Access Compliance Report

Public Rights-of-Way

Intersection ID: 50321	Main Street: BELMAR_PLACE_RD	Cross Street: CINDY_LN	Location: SW
ADA ID: C3B3C3777A95	Ramp Type: Directional1	Initial Pass/Fail: Fail	Overall Compliance: No
		Severity Score: 12.5

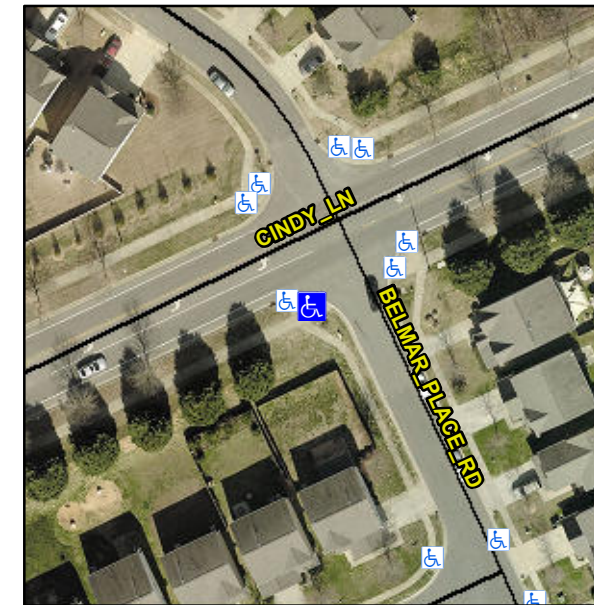
R304.2.2

Compliance	Description	Data	Compliance	Description	Data
N/A	Ramp Length (in)	112.0	N/A	Grade Break?	N/A
Yes	Ramp Width (in)	69.5	N/A	Grade Break Slope (%)	0.0
No	Ramp Slope (%)	10.7	N/A	Grade Break XSlope (%)	0.0
Yes	Ramp XSlope (%)	1.9			
N/A	Flare Type LT	N/A	N/A	Flare Type RT	N/A
N/A	Flare Slope LT (%)	N/A	N/A	Flare Slope RT (%)	0.0
N/A	Flare Traversable LT?	N/A	N/A	Flare Traversable RT?	N/A
N/A	Landing Length (in)	0.0	N/A	DWS Provided?	N/A
N/A	Landing Width (in)	0.0	N/A	DWS Contrast?	N/A
N/A	Landing Slope (%)	0.0	N/A	DWS Length (in)	N/A
N/A	Landing X Slope (%)	0.0	N/A	DWS Full Width?	N/A
N/A	Landing Curb? (Y/N)	N/A	N/A	DWS Offset LT (in)	N/A
N/A	Shared Landing?	N/A	N/A	DWS Offset RT (in)	N/A
N/A	Gutter Ponding?	0.0	N/A	Gutter Slope (%)	N/A
N/A	Gutter Lip Ht (in)	0.0	N/A	Gutter X Slope (%)	N/A
N/A	Painted X Walk1?	No		Road Slope (%)	3.5
	X Walk 1 Direction	To E		Road X Slope (%)	6.1
	X Walk 1 Width (in)	N/A		Clear Space?	N/A

Remove & Replace Entire Ramp.
